|   | 1   | 2   | 3 | 4 |
|---|---|---|---|---|
| A | <div><div>Revision Changes</div><div><div>SCHEMATICS</div><div>REV 01</div><div><div>*Changed U2 to Onsemi LDO NCP161BFCT250T2G</div><div>*Changed R1 to 5.1k</div><div>*Changed C3 to 220pF</div><div>*Changed C1 and C2 to 2.2uF</div><div>*Changed Q1 - G1 to GPIO from KL03</div><div>*Added GPIO to B1 pin on KL03</div></div></div></div> | <div><div>SCHEMATICS</div><div>REV 02</div><div>03/22/18</div><div><div>*changed R2 to 82ohms</div><div>*changed R3 to 47K ohms</div></div></div> |   |   |

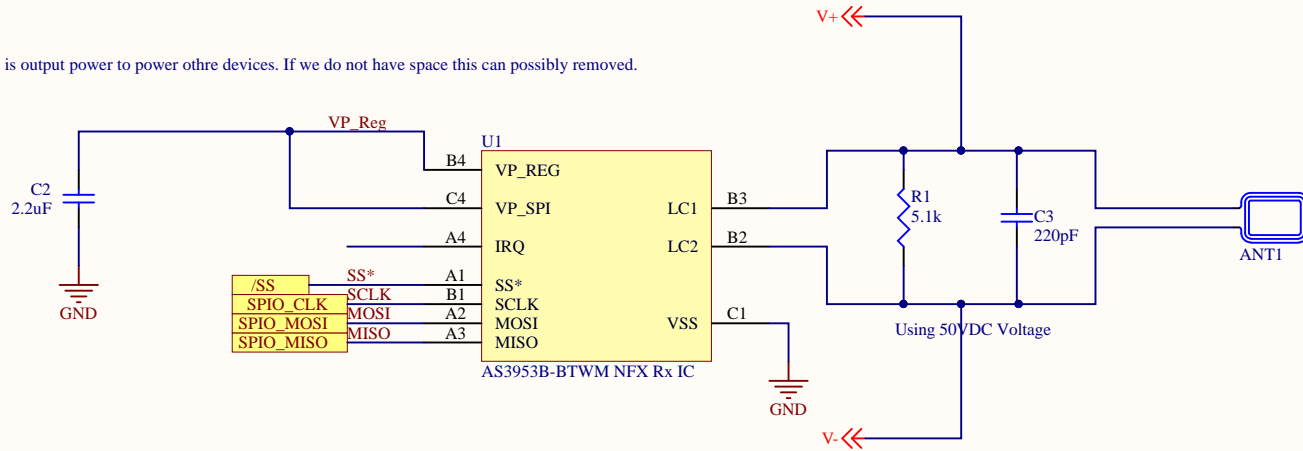
V\_REG is output power to power othre devices. If we do not have space this can possibly removed.
